From: DaSilva, Luis [REDACTED]
Sent: 26 April 2019 14:28
To: Planning.Responses
Subject: planning application consultation. - FG/29/19/PL

Your Ref
FG/29/19/PL
Our Ref
PLAN-027472
Date
26/04/2019

Proposal: Erection of 1 No. 2 bed dwelling (resubmission following FG/194/17/PL).
Site: South Point 1 Beehive Lane, Ferring, BN12 5NL.
FG/29/19/PL

Southern Water MapGuide Browser

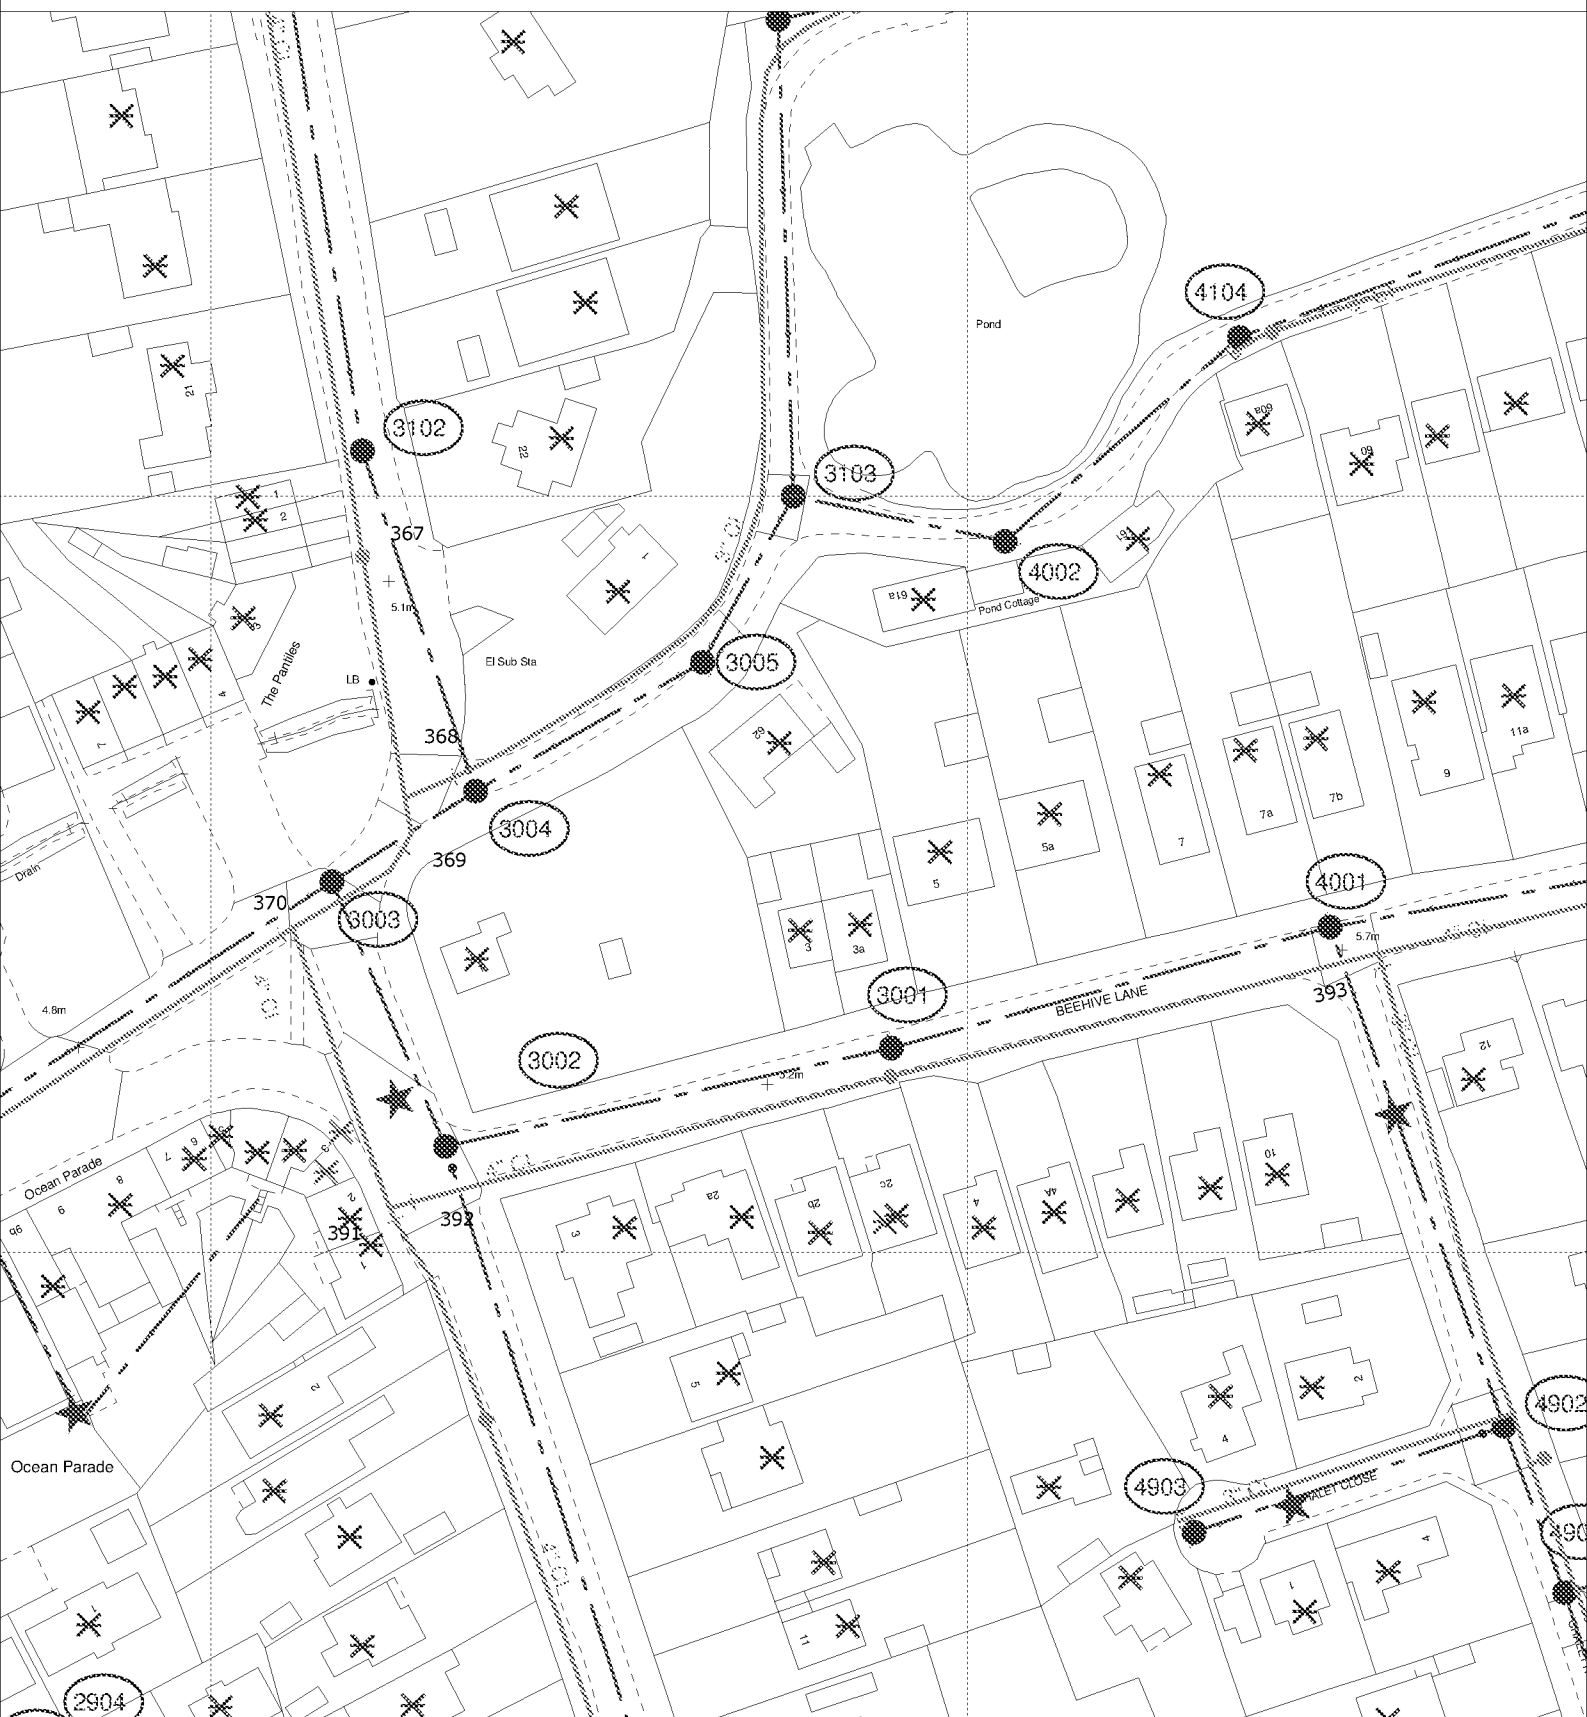
Please find attached a plan of the sewer records showing the approximate position of a public sewer in the vicinity of the site. The exact position of the public sewers must be determined on site by the applicant before the layout of the proposed development is finalised.

- No development or new tree planting should be located within 3 metres either side of the external edge of the public sewer.
- No new soakaways should be located within 5m of a public sewer.
- All existing infrastructure should be protected during the course of construction works.
